SUNDRY NOTICES AND REPORTS ON WELLS

OXY Excalibur 1
Federal

30-015-30771

OXY USA WTP LP - Proposed
OXY Excalibur Federal #1
API No. 30-015-30771

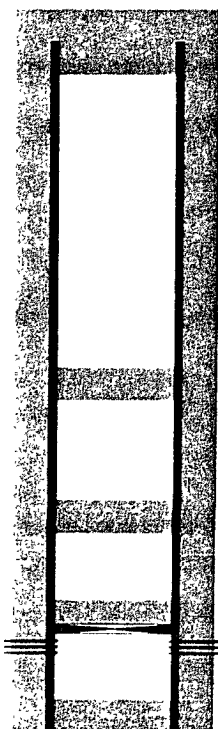
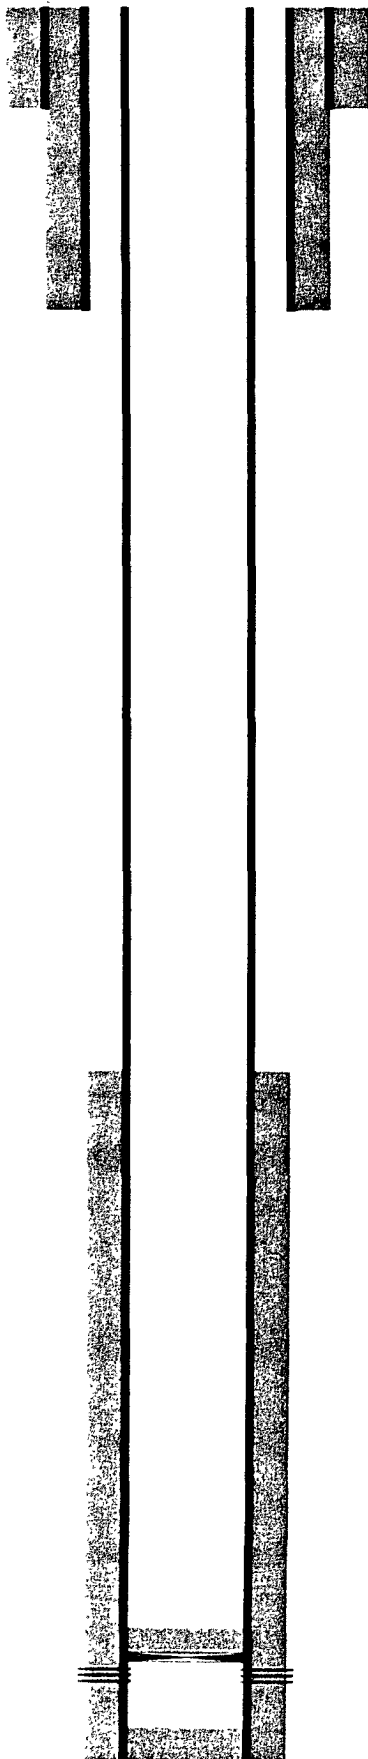
1. Approval is granted to P/A this well with the following modifications to the program:
2. A 45 sack plug; using class H cement, will be set @ 8912' to cover the top of the Morrow formation.
3. The top of the Wolfcamp will be covered by a 40 sack plug @ 6054'. This plug and all other plugs can use class C cement.
4. All of the plugs in the submitted procedure below 5800' can be eliminated.
5. The surface plug must be circulated to the surface from 100 feet.

*** All plugs, including the surface plug, should leave at least 25 sacks of cement inside the casing and be at least 100 feet, plus an additional 10% for each 1000 feet of depth.**

40
25sx @ 7675-7575' 6054-5954'

45
25sx @ 8335-8235' 8912-8812'
